LINCOLN COUNTY
DEPARTMENT OF ENVIRONMENTAL HEALTH
AFFIDAVIT OF WASTEWATER TREATMENT AND DISPOSAL SYSTEM COMPLIANCE REVIEW FOR SYSTEM INSTALLED, REPAIRED OR REPLACED WITHOUT A VALID PERMIT

Type of System Work Reviewed:

Address or Location: 171 Carpenter Ln, Eureka, MT 59917

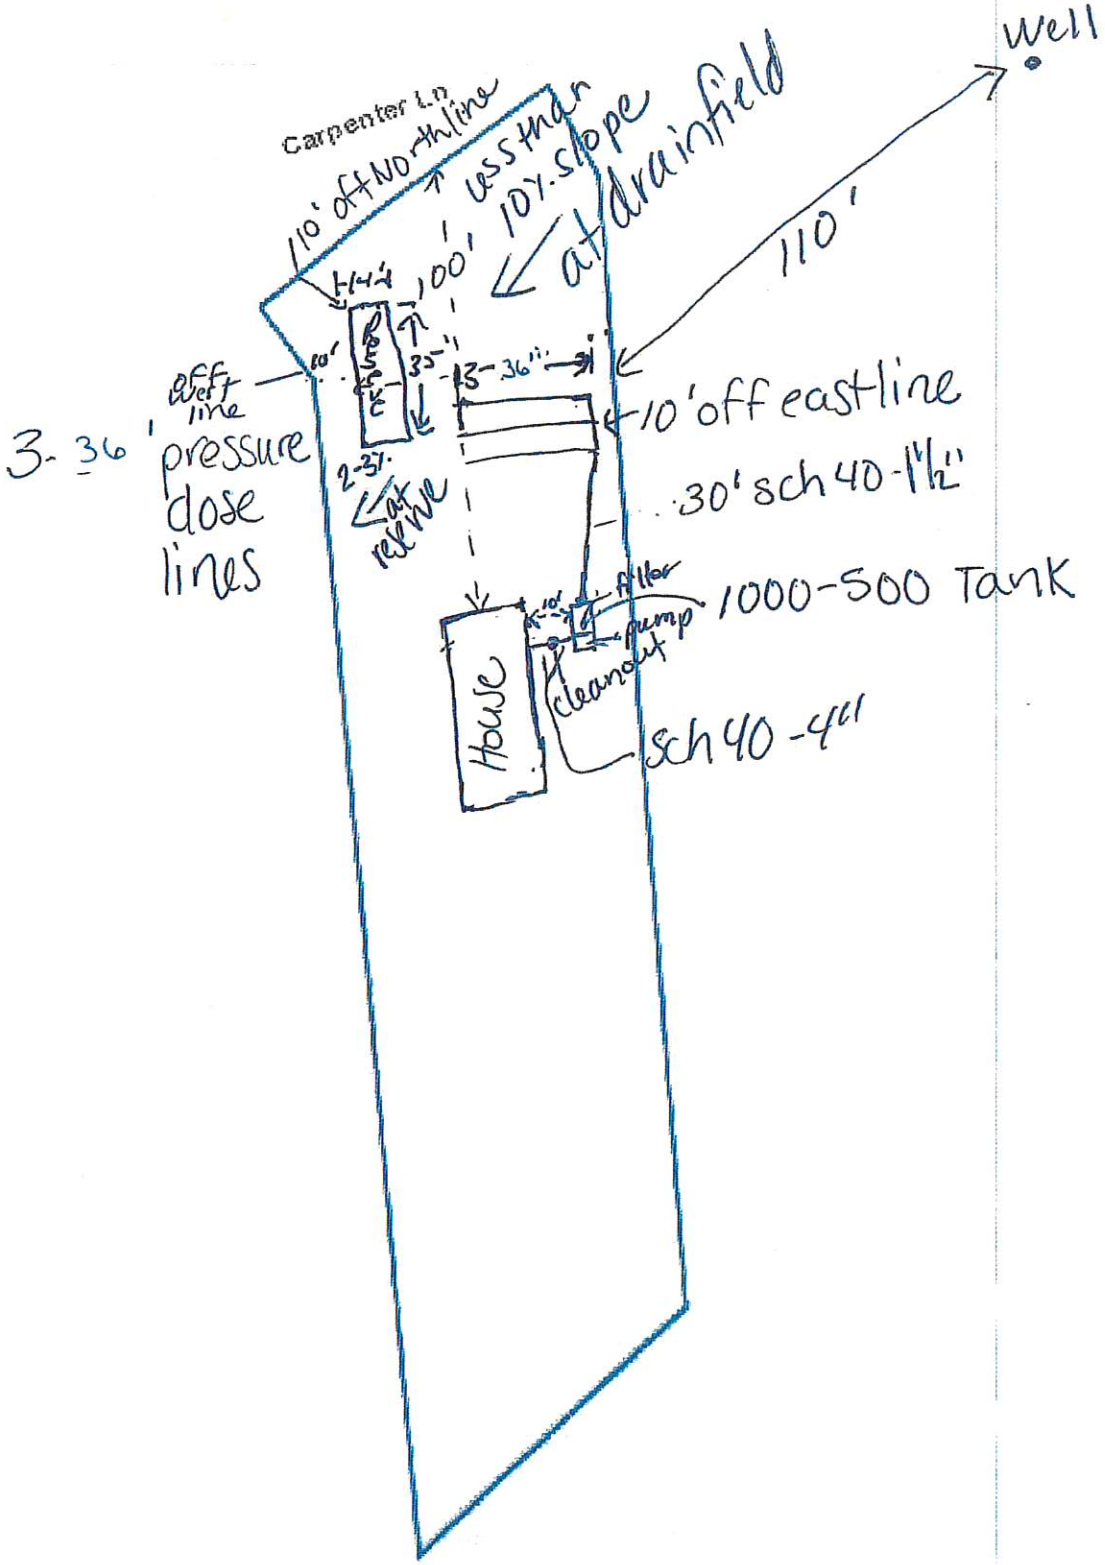
I, Nicholas Raines, have inspected/reviewed the components of this system as listed above and found it to be in compliance with the sizing, construction, orientation and operating requirements of Chapter 17, Subchapter 36 A.R.M., Circular DEQ-4 and Lincoln County Wastewater Regulation.
